SUBJECT: NRC SITE VISIT TO THE OCONEE NUCLEAR STATION ON
JUNE 15, 2009

SUMMARY OF NRC SITE VISIT TO THE OCONEE NUCLEAR STATION JUNE 15, 2009

Saddle dikes at Jocassee Lake are protected from wave action by rip rap on sides facing lake. Top: Saddle Dike #2. Middle: rip rap on lake side of Dike #1. Right: downstream side of Dike #1 has grass but no rip rap (french drain is visible along toe of dam).

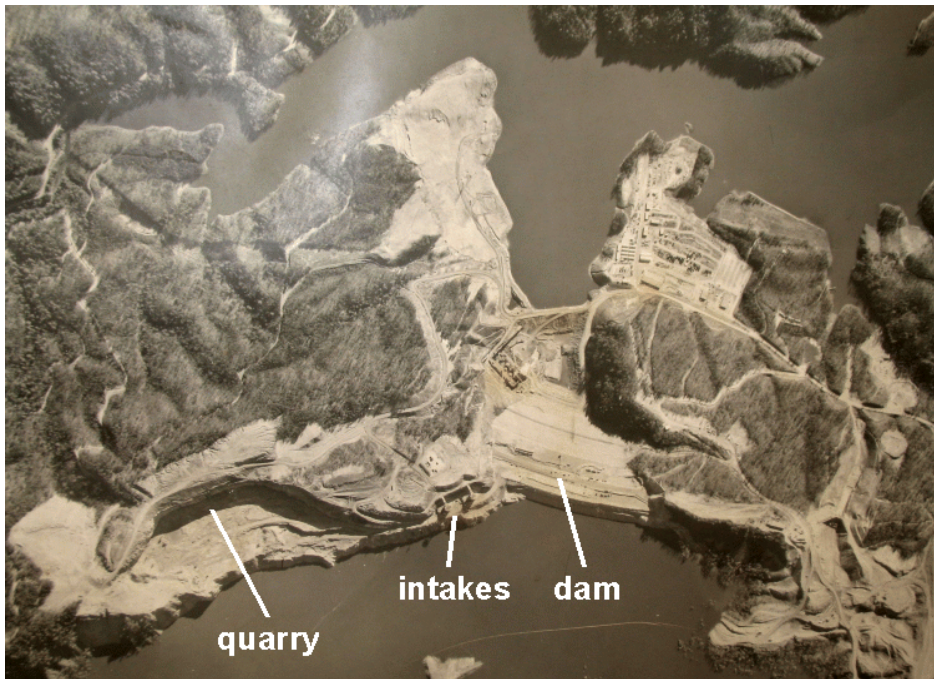
There are two earthen saddle dikes west of the main Jocassee dam, which could potentially function as an uncontrolled spillway in the event of a severe storm coupled with an inoperable spillway gate. The crest elevations of these dikes are the same as that of the main dam. These two saddle dikes could provide emergency outlets that could prevent overtopping failure of the Jocassee dam. Overtopping failures are the most hazardous for any dam. As shown in the photos below, Saddle Dikes #1 and #2 do not have rip rap on their downstream sides. If overtopped, they would rapidly erode forming breaches that would drain the reservoir down to the base level of the dikes. This would still allow the reservoir to retain most of its water volume, averting a catastrophic emptying of the entire lake. Both dikes are protected from wave erosion by rip rap armoring on the lake-facing slopes. Lowering the saddle dikes by ~0.5 m would provide further assurance that if a probable maximum flood inflow occurred to Jocassee Lake, failure of the saddle dikes would prevent overtopping and catastrophic failure of Jocassee Dam.
